# Further Information Response Report

**Proposed Age Friendly Scheme Tay Lane,  
Rathcoole, Dublin 24**

On behalf of  
**Riverside Projects Limited**

December 2022

Figure 1 – Proposed Public and Communal Open Space

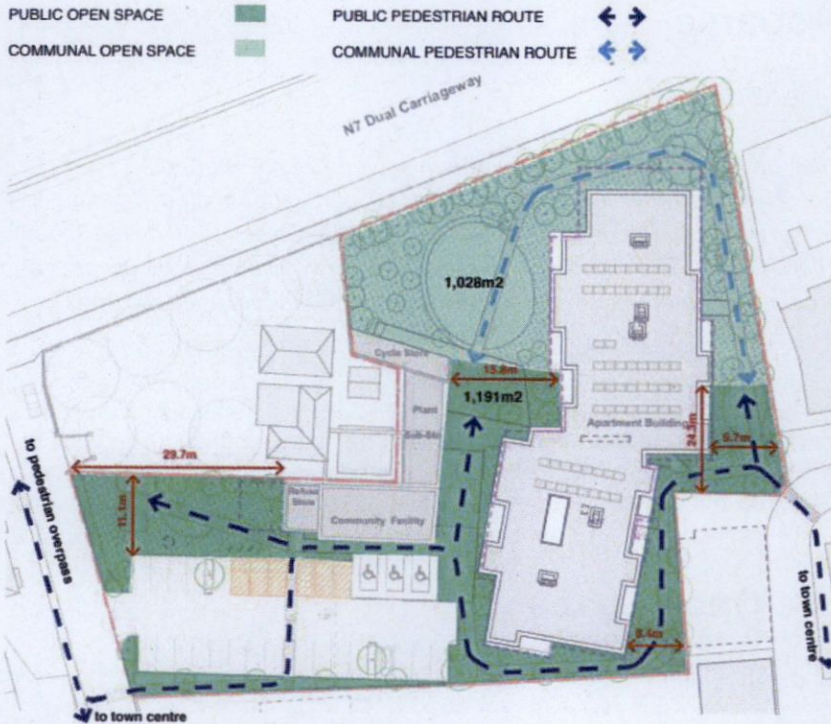
*"The proposed public open space consists of the pedestrian path and surrounding verges/spaces between the western and eastern pedestrian accesses, and around the southern wing of the proposed building. This is linear incidental space and does not fit the qualitative requirements of public open space under the County Development Plan. The applicant is requested to provide additional information specifying how 10% of the site area will be provided as Public Open Space to the qualitative standards as set out in the CDP and on top of the requirements for Communal Open Space."*

In response to item 10 revised landscape drawings have been submitted which show outdoor gym equipment and outdoor seating within the public open space area extending to 1,191 sq.m. The CDP states that all 'Public open space should have active and passive recreational value' (Section 6.7.2). It is submitted that the proposed open space area provides for both active and passive recreation. An east to west public pedestrian route has been incorporated into the design of the scheme to provide an attractive landscaped route into the town centre as an alternative to the trafficked route along Main Street. New outdoor gym equipment has been located alongside this route to enhance opportunities for active recreation and a new seating area is proposed adjacent to the Tay Lane entrance which has also been enhanced by opening the existing watercourse here. The Design Statement Addendum also sets out a detailed response to item 10 (see Section 3.10).

Figure 2 – Revised Site Layout including Revised Internal Pedestrian Footpath Layout (11)

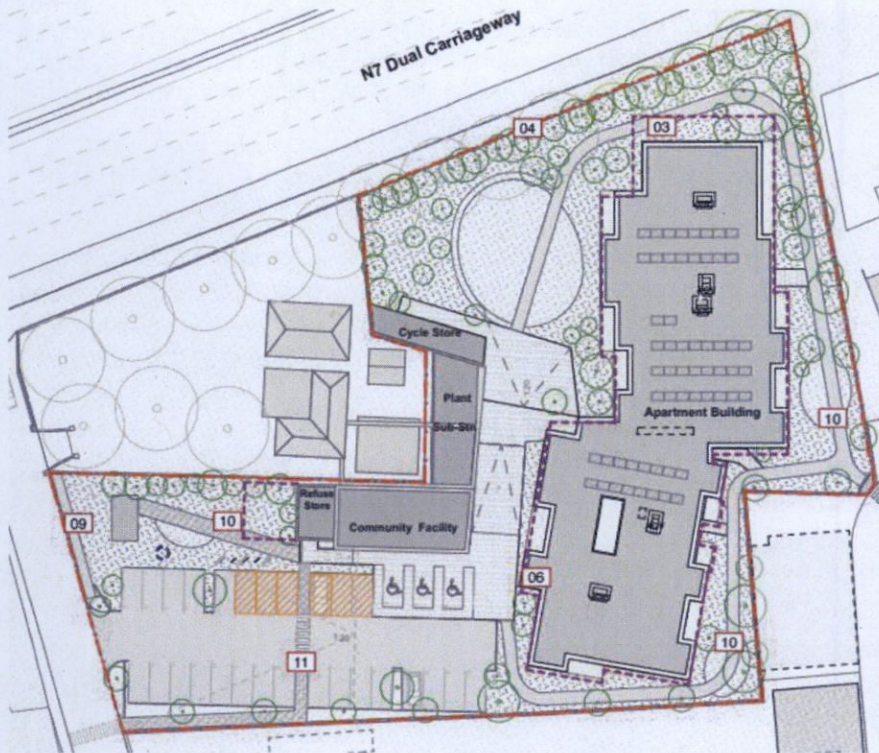
*“(a) The pedestrian access to the site from Tay Lane is located north of the car park. It is considered likely that pedestrians would simply walk through the car park. The car park should be reconfigured to make some provision along the south of the site for pedestrians, whether it is demarcated and raised footpath through the car park, or a footpath south of the parked cars.”*

In response to item 11a, revised architectural drawings have been submitted showing the main pedestrian entrance off Tay Lane located further south and a pedestrian crossing within the car park. The Design Statement Addendum Overview of Changes (refer to Section 2.1) identifies the revised pedestrian footpath layout as shown in Figure 2 (item 11) below.
